RFB NO. 313086 - ADDENDUM NO. 6

### ARCTIC ANIMAL EXHIBIT AND CONCESSIONS

This Addendum is issued to modify, explain or clarify the original Request for Bid (RFB) and is hereby made a part of the RFB. Please attach this Addendum to the RFB. **Bidders must acknowledge all Addenda on the Bid Form.**

**S5.1**

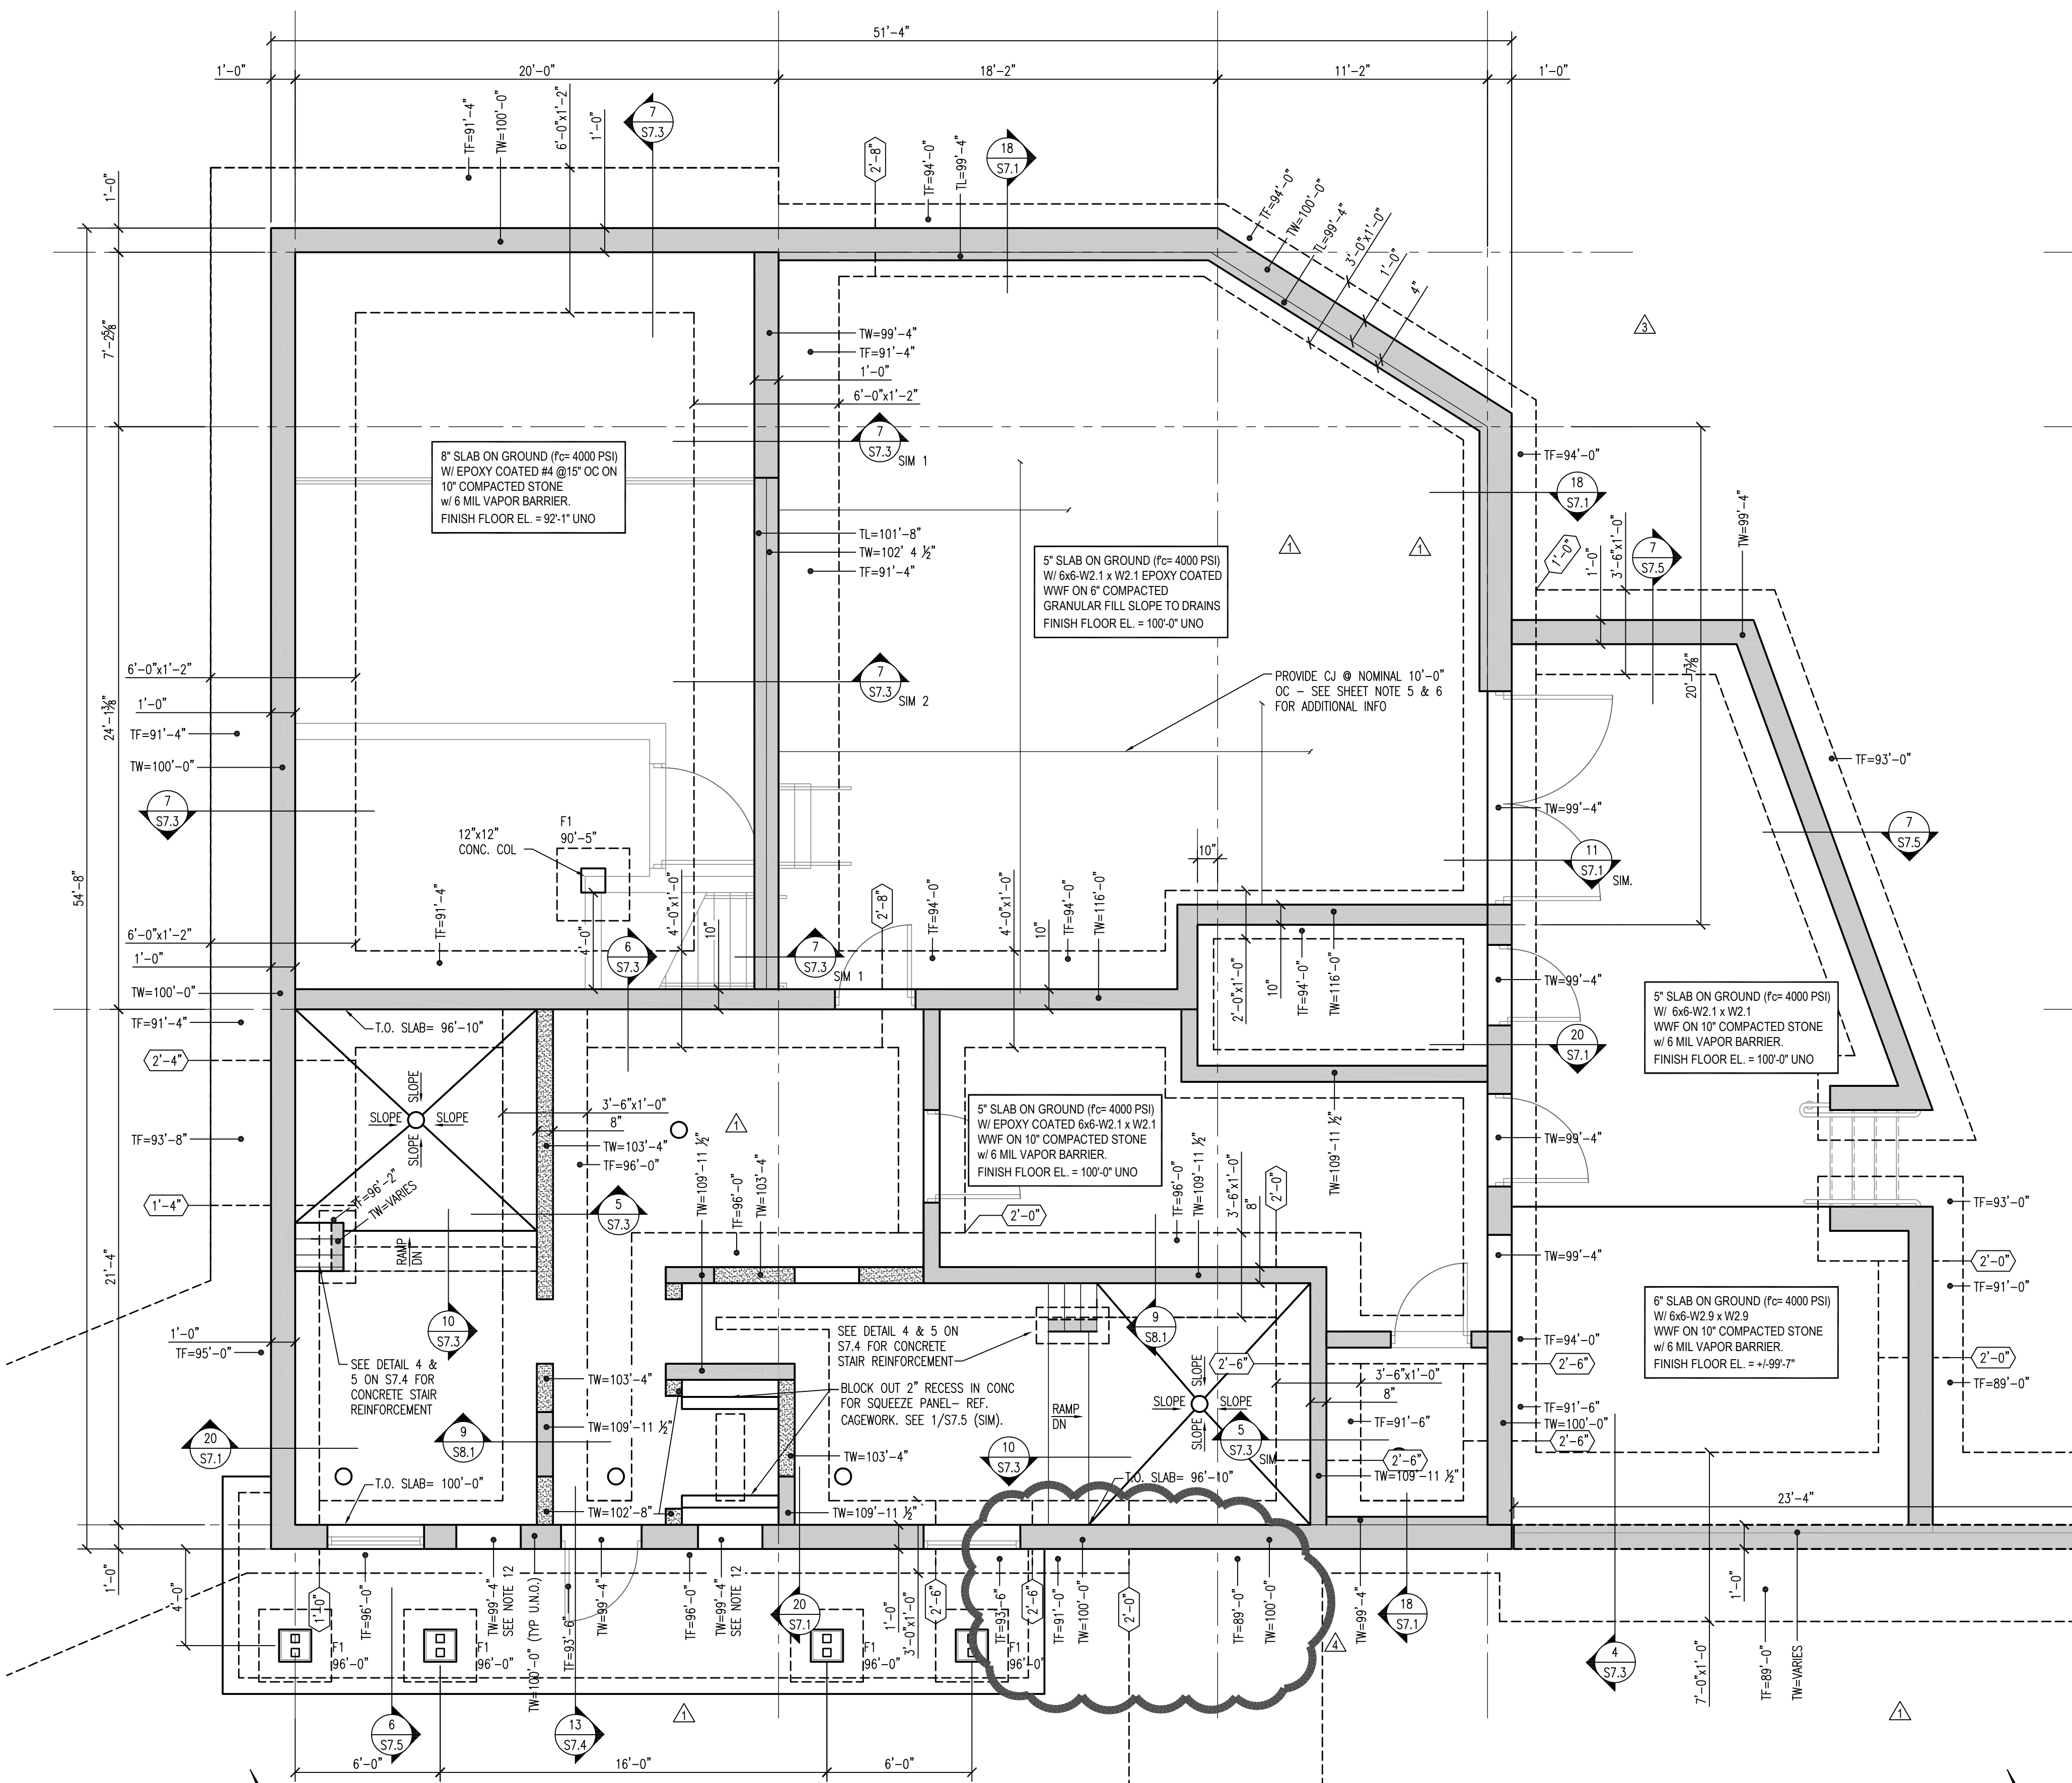
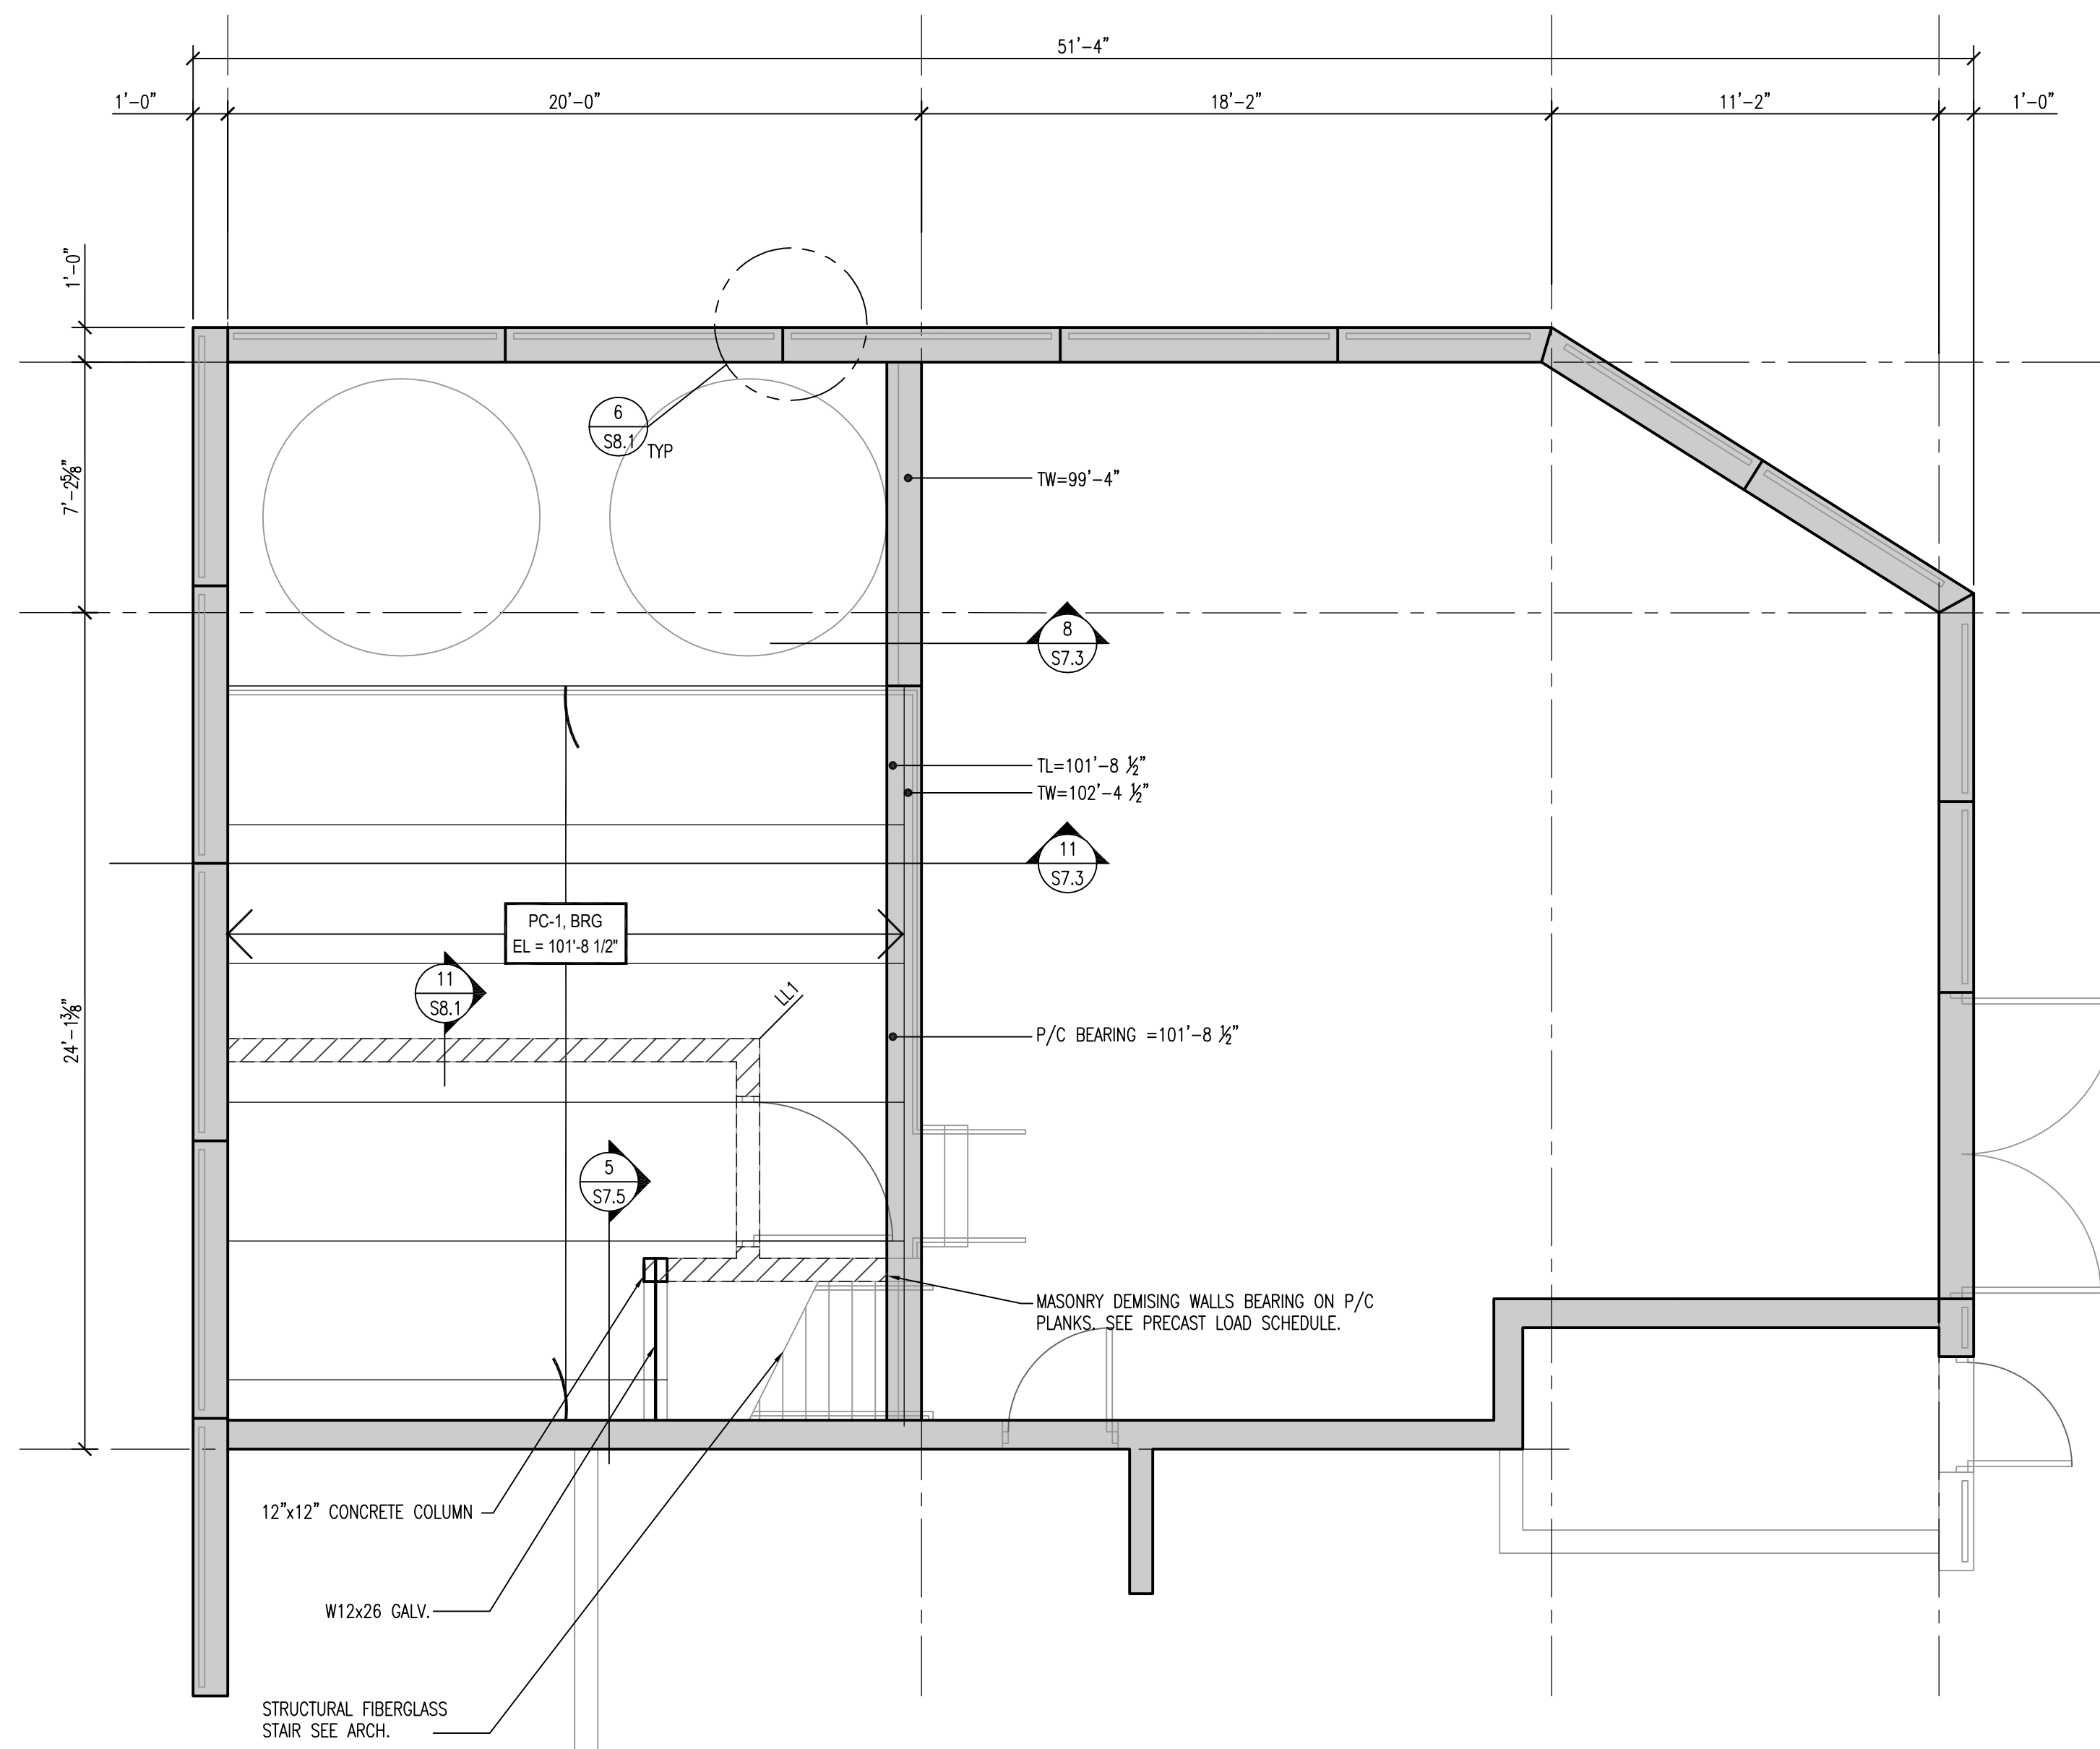
### **30. Sheet S5.1- Seal Holding/ Life Support Foundation Plan**

- Shifted footing step locations 1'-6" west to accommodate widened site wall footing
